Re: Proposed development N70 Waterville to Ballybrack Road Improvement Scheme
Townlands of Waterville, Ballybrack and Eightercua, Co. Kerry

Re: Application of Kerry Council for Consent for Proposed Development (N70 Waterville to Ballybrack Road Improvement Scheme) – Our Clients Barry & Bernice O'Donovan, 5 Benjamin Close, Ballybrack, Waterville, Co. Kerry

PROPOSED N70 WATERVILLE TO BALLYBRACK ROAD IMPROVEMENT SCHEME

Submission made on Behalf of
Barry & Bernice O'Donovan,
5 Benjamin Close, Ballybrack

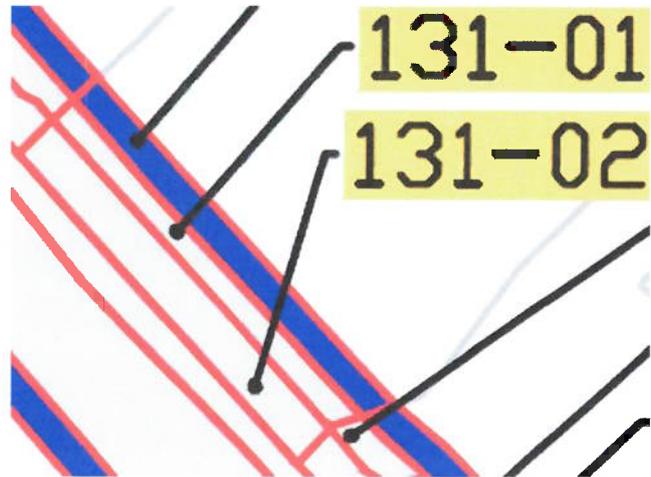
2.1: There will be the obvious (c. 3%) loss of overall site area, but when the loss of lawn area after allowing for the dwelling itself and the screen planting , the loss of actual lawn area, will

2.2: In addition, there is a distinct lack of clarity and exactness in regard to the precise extent of the “take” suggested –

- the maps are not as definitive as they might seem – the precise computer-drawn lines on the CPO maps are presumably accurate but are, to scale, almost 1 m wide – is the boundary on the inner or outer edges or the centreline of this 1m width? Is the new roadside boundary to be constructed within the “take”? (it would appear that there is insufficient provision for same).

- with a 40m road frontage, Plot 131.01, a rectangle of 88m² (Area from CPO schedule) would have a depth of 2.2m – is this correct?.
- Plot T131 (the “temporary” plot_ is quoted in the CPO schedule as having an Area of 0.108hA, or 1080m². With a 42m frontage (plot Southern Boundary is not “Square”), that gives a depth of c. 25.7m – this is obviously incorrect, and possibly should have read 0.010 or 0.018hA, giving widths of c. 2.4m & 4m respectively, - which, if either, is correct?
- Given all of the above, what would in any case be a not-unreasonable expectation that the proposed land take would be physically pegged now becomes an essential exercise, and we would request that this be done urgently.

Chainage : 260.000m

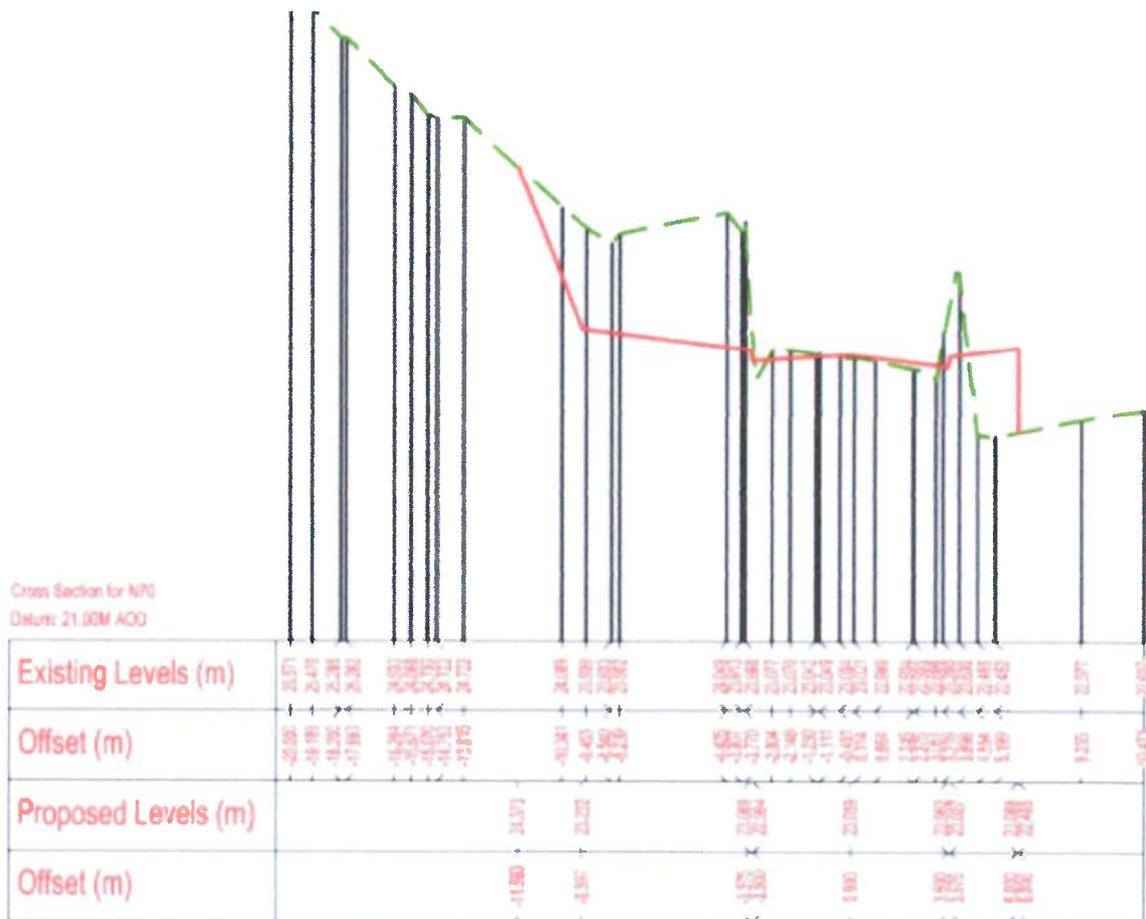
3.2: Shown overleaf is the Cross-sectional Detail as published for Ch 260m – i.e. at the centre of our clients’ property. It is understood that the vertical scale is, as would be normal in these cases, exaggerated, but there are some inaccuracies (or at the very least simplifications) in the Sections, not least in respect of the representation of the existing roadside ditch, which is both higher and wider than shown, but the position nonetheless shows what will be a very unacceptable picture for our clients

While the centre level of the road here is to be maintained, the revised camber suggested will raise the road edge by c. 100mm, and more significantly, the level immediately inside the existing ditch is shown as raised by 600mm+, and worse, rises further from there to the inner edge of the proposed “take”, and, worst of all, filling in, as it does so, the “Swale” at the lowest point of our Clients land. While it is unlikely that the levels can be altered significantly from those proposed, it is very much the case that the levels of accuracy & of detail of the existing and proposed levels required to properly illustrate the effects on our clients property are missing, and that the reality of the detrimental effect of the alteration of relationship between our the levels of clients’ lawn and the road is not fully illustrated.

3.3: What is however very obvious from the proposed section is that the section of our clients’ lawn near to the road slopes significantly towards the road, and that the proposed “take” removes the lowest end of that slope. As will be illustrated later, the soakage/percolation here is poor, and the surface water drainage opportunities very limited. For further discussion on this, see “Drainage Issues” below.

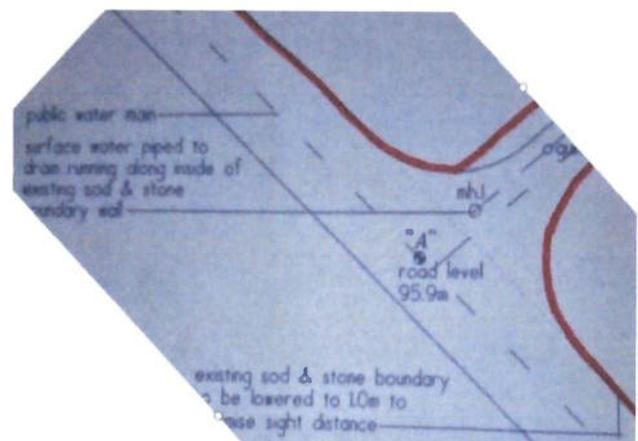
4.3: The Plans on foot of which the initial Planning (485/97) was Granted were, to put it mildly, of a poor standard. The surface water disposal for the individual sites was hardly mentioned, and the site road drainage detail, consisted of some GTs connected to a very basic pipe, and discharging linearly one to the other (with some shown as very basic gully to gully “straight-thru’ connections), starting at the Northern (inner) end, eventually discharging at the abutment with the N70 to what was described as “*drain running along inside of existing sod & stone boundary wall*”. Apart from the pipework arrangement being entirely substandard, and depending on an effectively non-existent discharge point, this arrangement was patently unworkable on the particular site, as the gradient from what was shown as the highest manhole or gully (outside site 6) was entirely against the natural slope, with, were it to be installed as shown, a dig of up to 7m thru solid rock being required!! (The Road Level at G3 is c. 7m higher than at G5) (see Plan below).

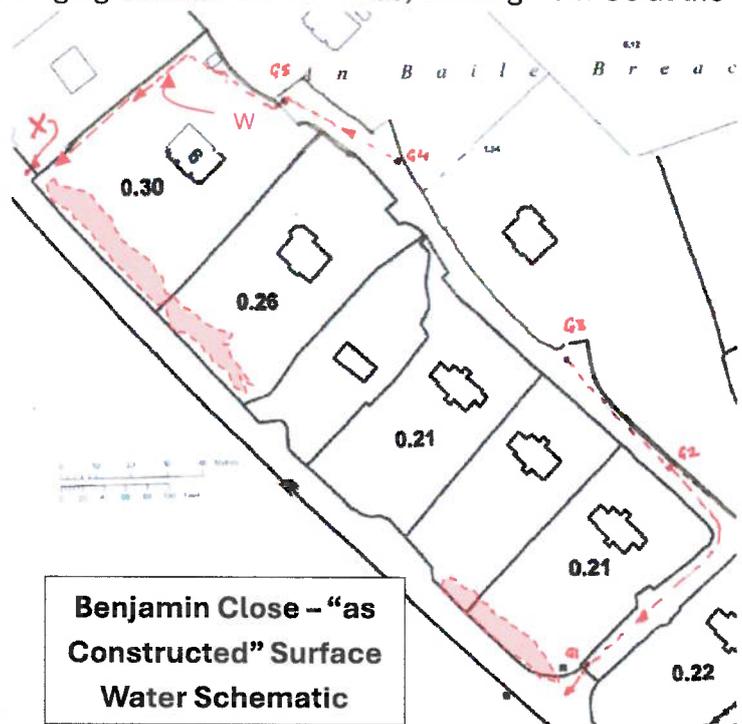
4.4: What was actually installed was 2 separate SW systems, both substandard & both discharging to the same non-existent drain – an outline of this arrangement, involving some assumptions/guesses, but easily accurate enough to illustrate the principles is shown on right. It shows 5 Gullies in total, 3 discharging towards the entrance, starting from G3 at the high point, and G4 & G5 apparently discharging along the North-Western boundary of No. 6 via a recently partially-discovered pipe, but eventually reaching the N70 boundary thru’ a combination of pipes, stone drains and surface flow. In reality, as the Gullies are almost all located on the highest side of a one-way camber, they are ineffective, and all of the water discharges either onto to the original public road near G1, or into No. 6, ending up in the joint “swale” shared with No. 6 , and the position is further exacerbated by the fact that the level of the lawn of No. 5 is 500mm+ under the existing public road level.

(It does appear that there may have been some intention that the pipe installed along their North-Western boundary of No. 6 may have been intended to reach an adjacent pipe at Point “X” on the plan on the previous page, but that pipe is, firstly, effectively level with the pipe at point “W” on the same Plan, but

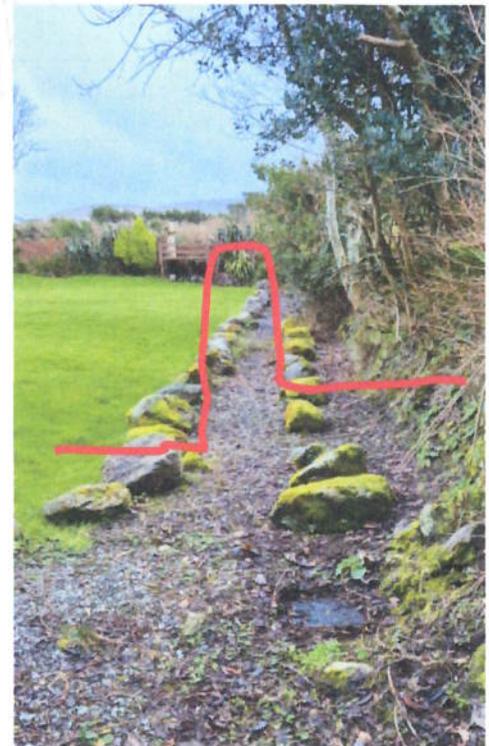
7.1: The Plan on Left shows the main trees in the Lawn of #5, along with, in Grey a double line of placed large stones which form an integral part of the Garden Design & Regime, as well as

forming a boundary or sorts to the aforementioned “swale”. These stones are also illustrated in the photo on Right on which we have superimposed, very approximately, the outline of the new filled ground & replacement ditch. The effect on the swale area is obvious, as is the need to relocate the double stone row further into the lawn area
